RE: Response to TCEQ NOD 3 Addendum – CCR105  
Luminant Generation Company LLC – Tatum, Rusk County  
Industrial Solid Waste Registration No. 31277  
EPA Identification No. TXD000821306  
Tracking No. 27220868; RN102583093/CN603256413

Table 1 - NOD Summary and Response  
Registration No. CCR105 - Luminant Generation Company LLC  
Application Deficiencies - Addendum to NOD 3

RE: Response to TCEQ NOD 3 Addendum – CCR Registration No. CCR105  
Martin Lake Steam Electric Station - Rusk and Panola Counties, Texas  
(SWR 31277; RN102583093; CN603256413; EPA ID No. TXD000821306)

Figure 5  
 ASH POND AREA  
 GEOLOGIC CROSS SECTION A-A'  
 WEST SIDE OF WEST ASH POND  
 THROUGH PROCESS WATER POND

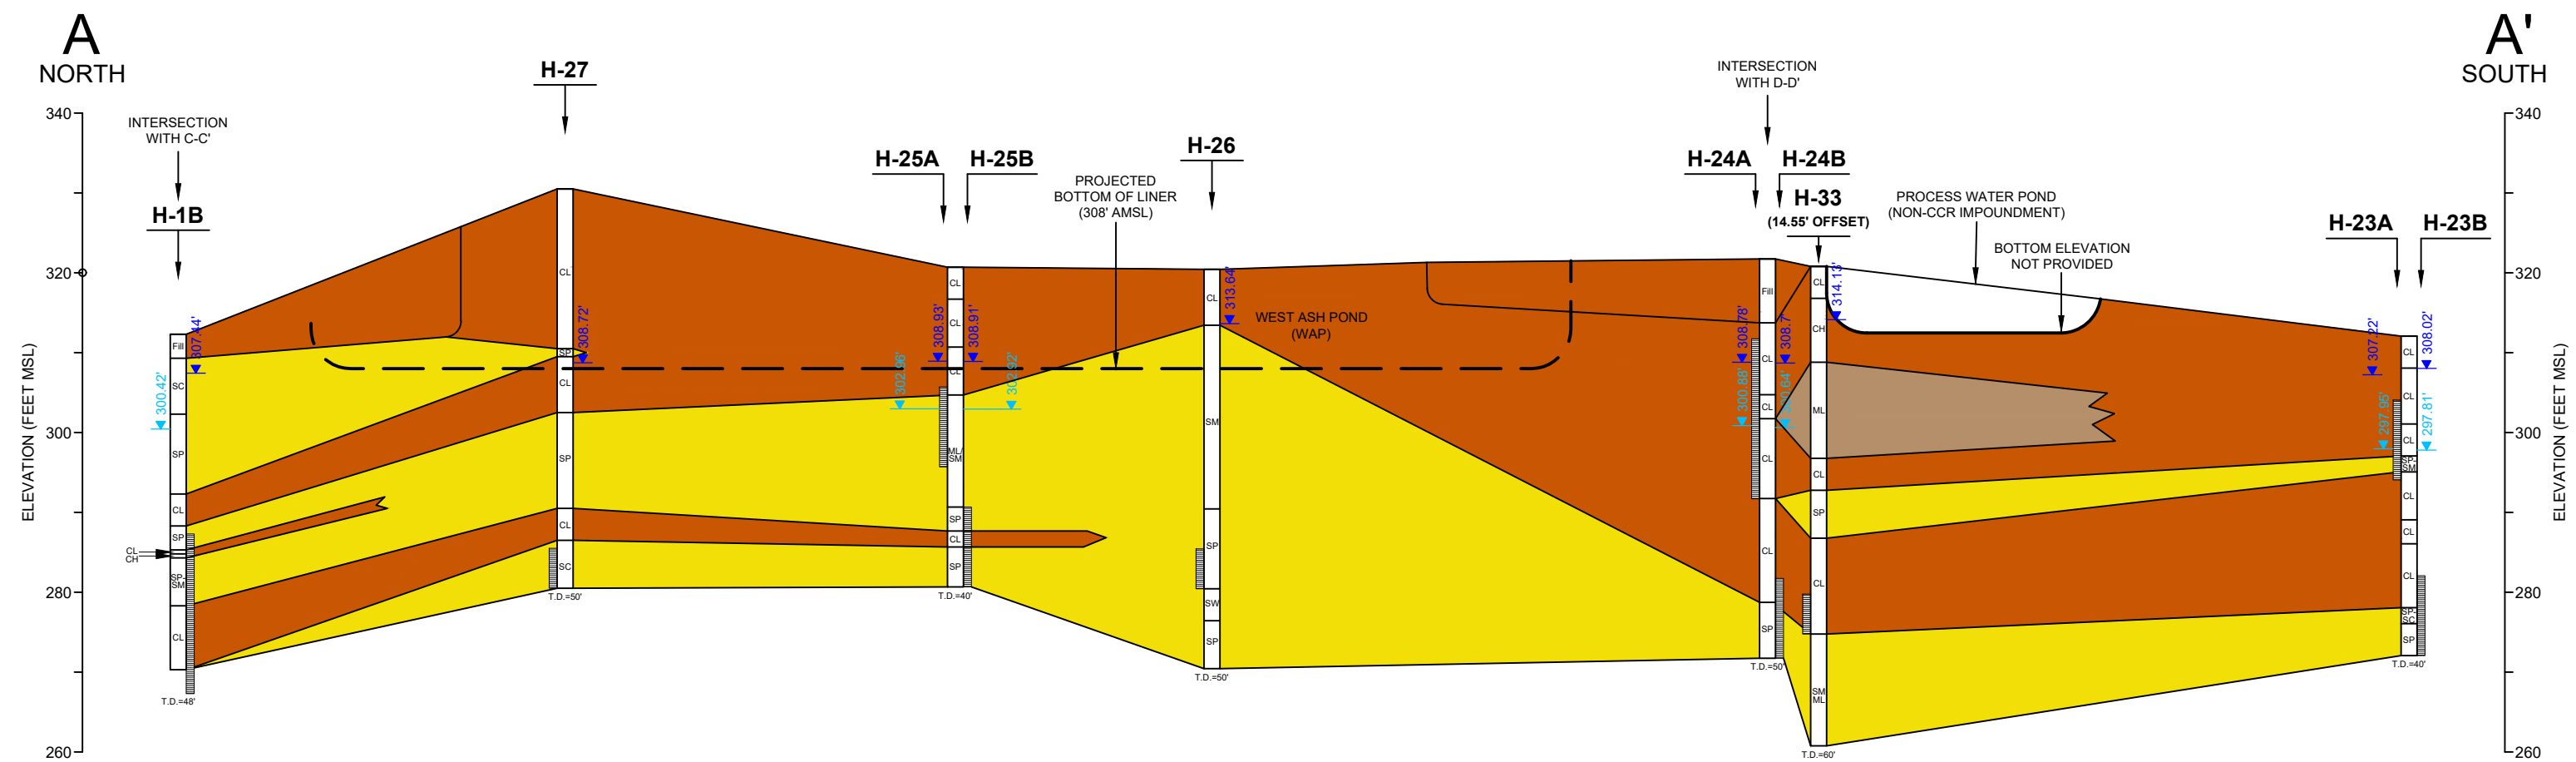
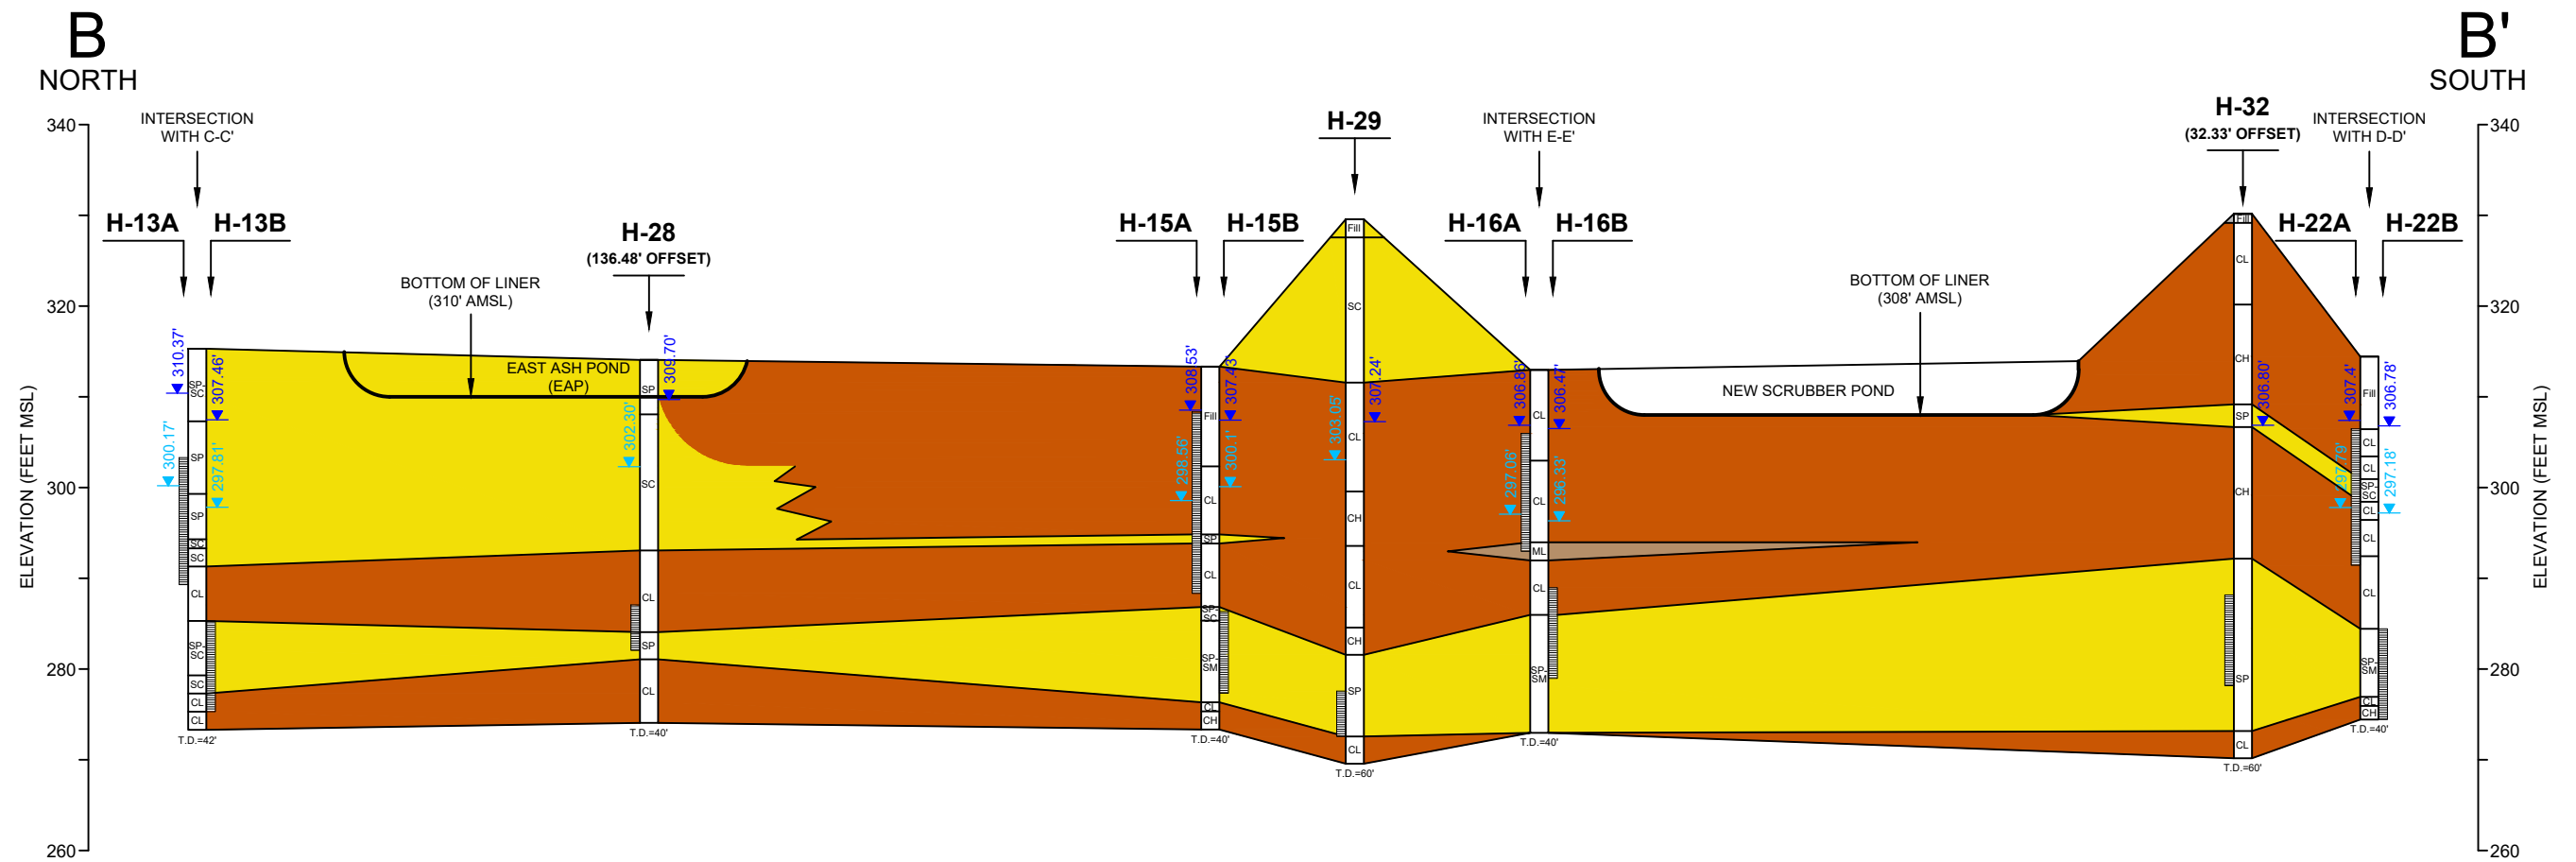
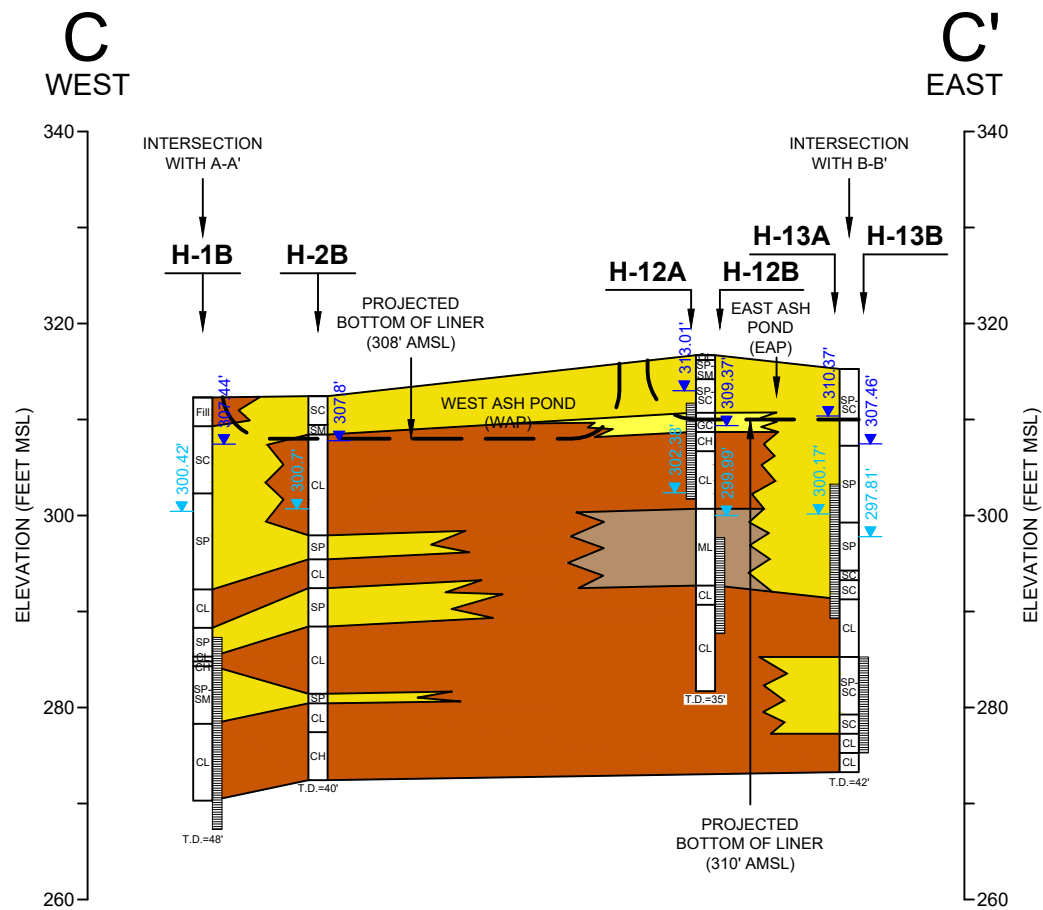
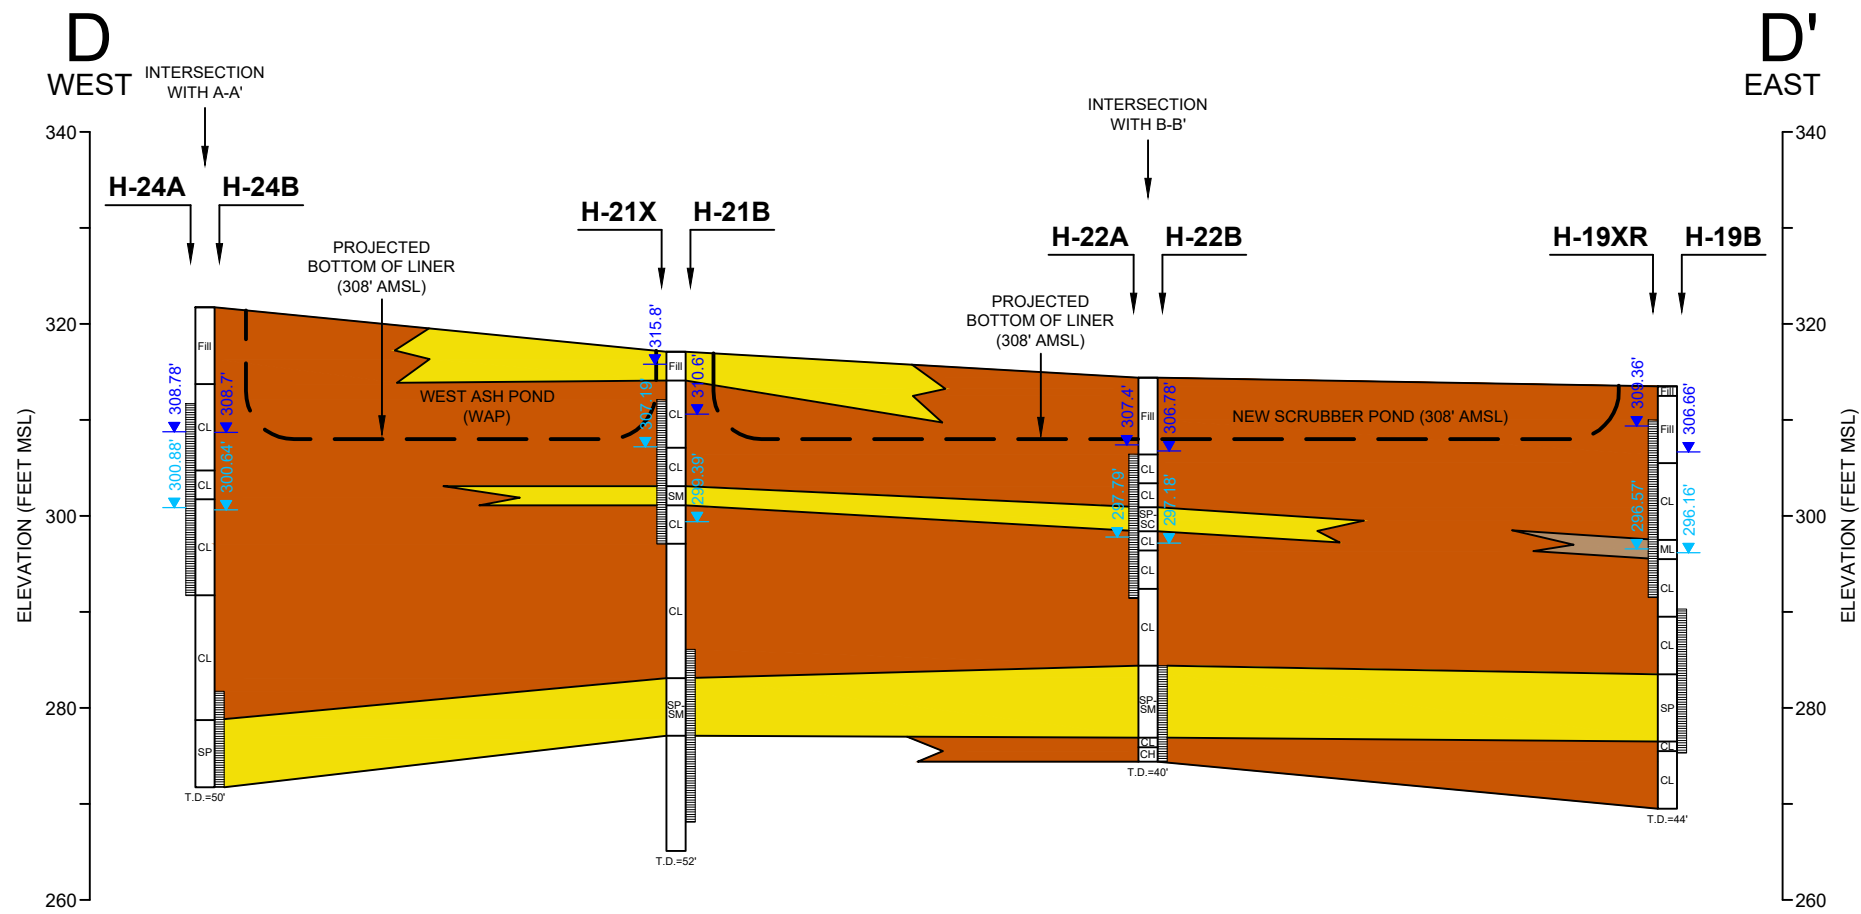
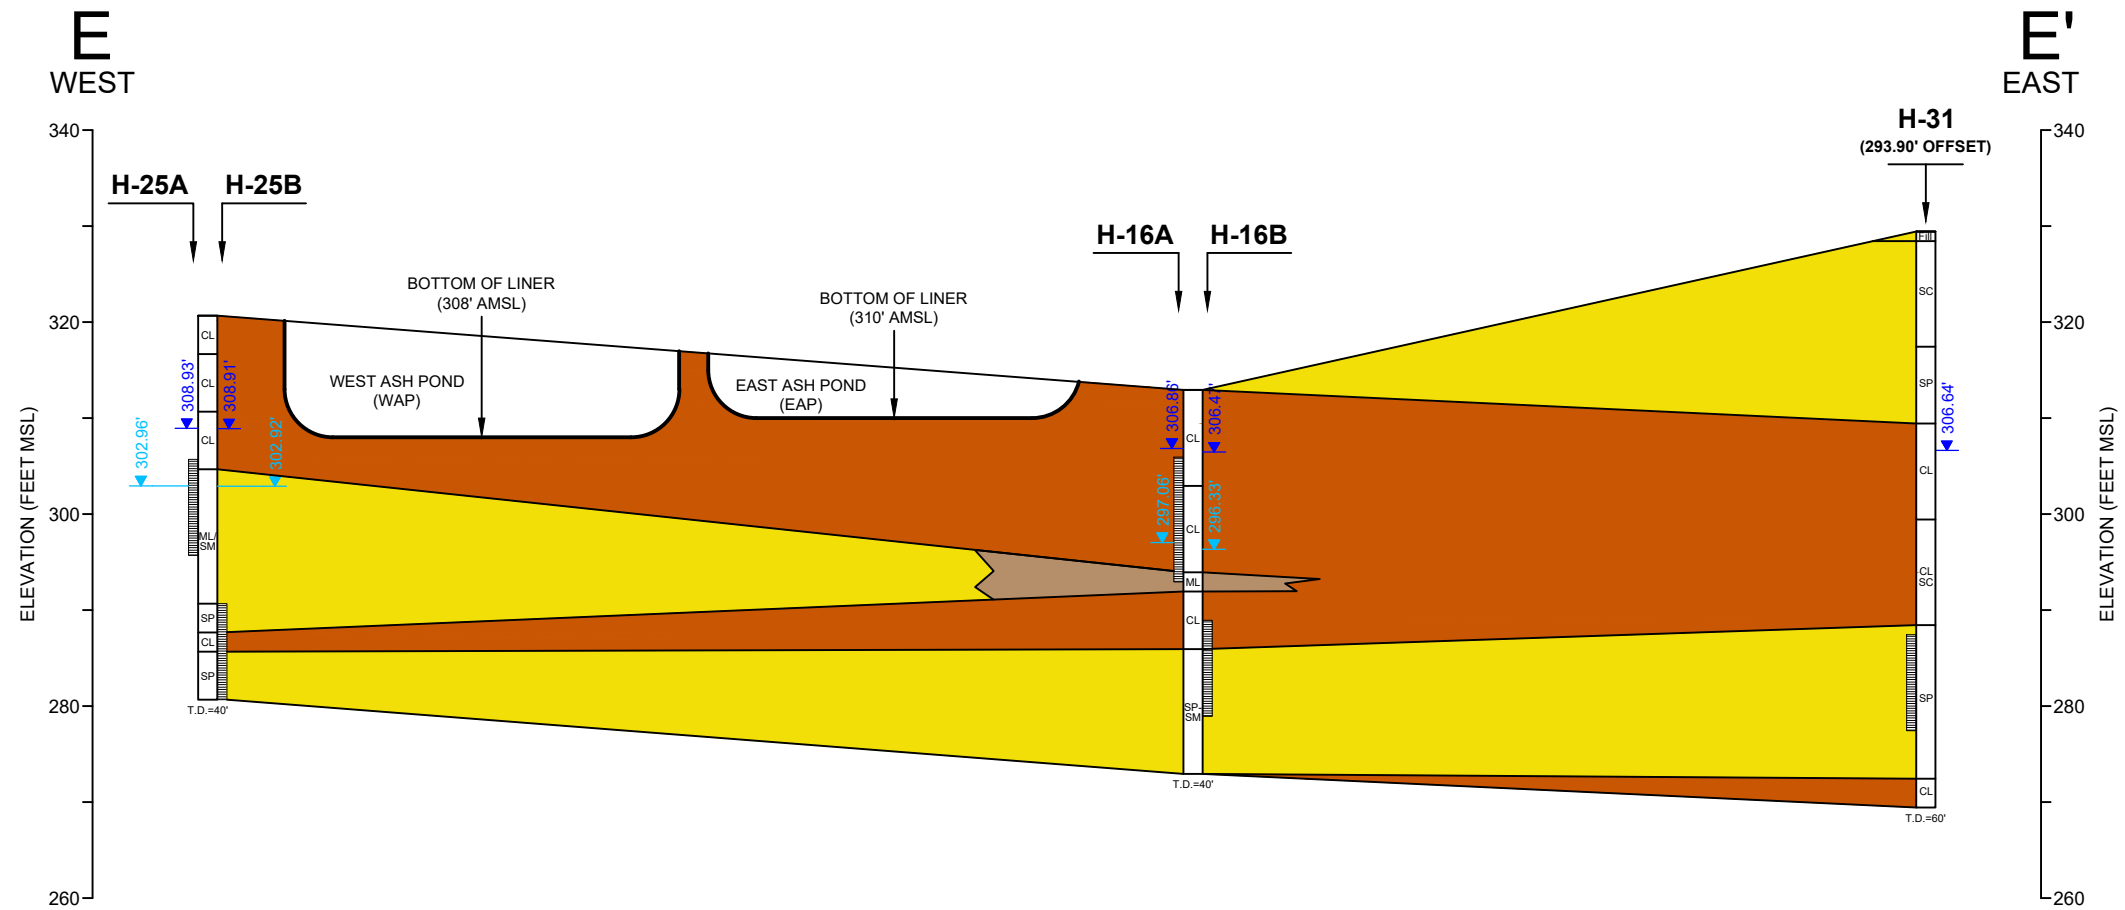
*Provide information on using H-26, H-27, and H-33 as background wells as the groundwater may be affected by the operations of the facility (e.g. coal piles) to the west, which is upgradient (based on applicant-supplied groundwater flow maps) to these background wells. This may be based upon:*
